MONTGOMERY COUNTY HISTORIC PRESERVATION COMMISSION
STAFF REPORT

Address:	21 Quincy St., Chevy Chase	Meeting Date:	12/21/2022
Resource:	Contributing Resource Chevy Chase Village Historic District	Report Date:	12/14/2022
Applicant:	Andrew and Jennifer Tulumello (Phillip Long, Agent)	Public Notice:	12/7/2022
Review:	HAWP	Tax Credit:	n/a
Case No.:	1014573	Staff:	Dan Bruechert
Proposal:	Alteration to columns on existing house and new addition.

EXHIBIT B

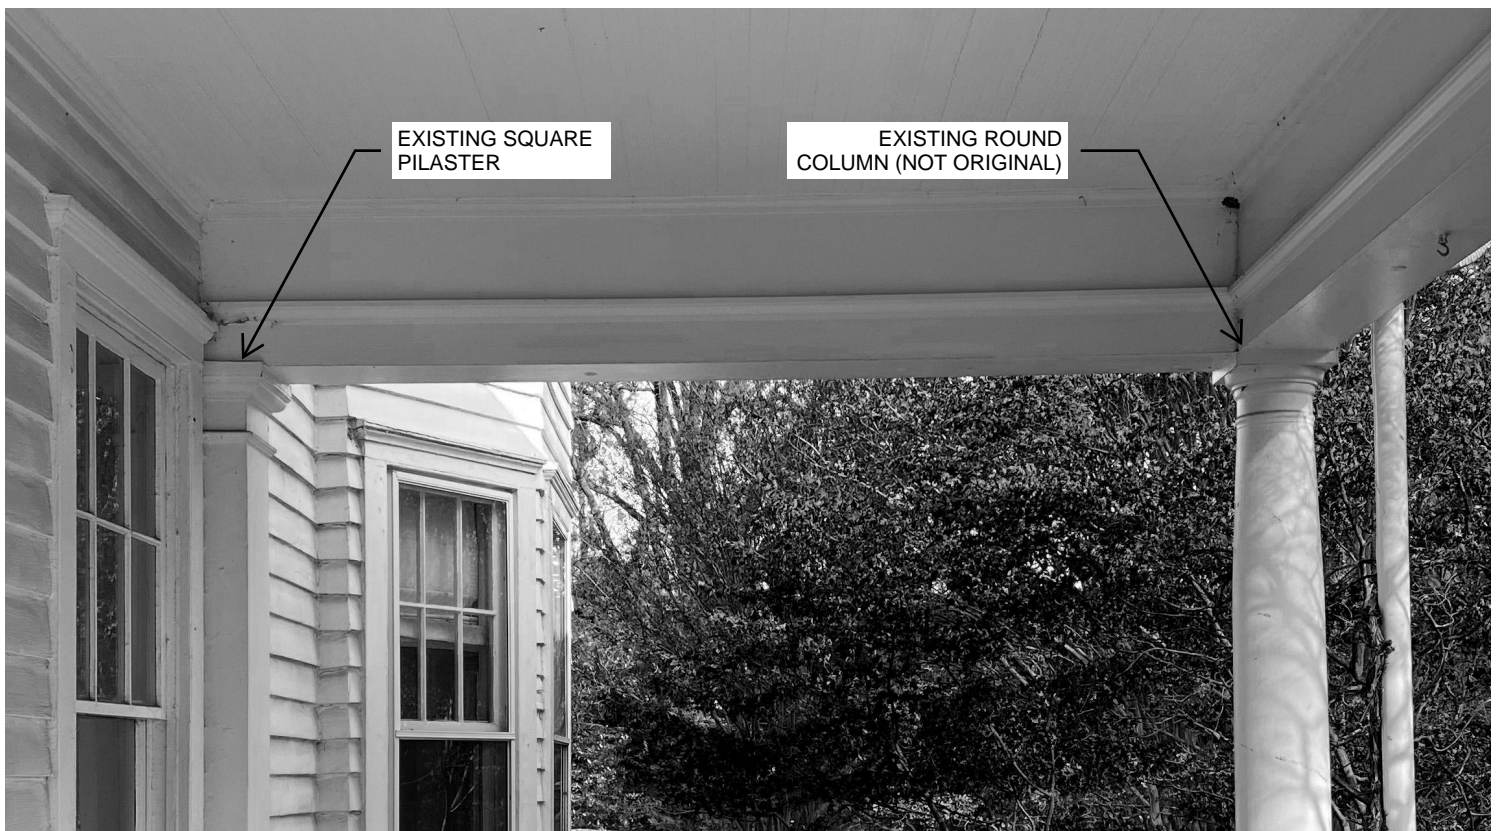
There do remain two square, wood half-columns on the walls of the original house, which we believe to be original (exhibit b). We believe the original porch columns to have been square as well. We seek permission to replace all of the existing round porch columns along the front and side porch with new square columns that are historically in keeping with the existing porch and house trim that remains. This includes (9) columns at the porches, and (8) at the porte-cochère, for a total of (17).

EXISTING SQUARE
PILASTER

EXISTING ROUND
COLUMN (NOT ORIGINAL)
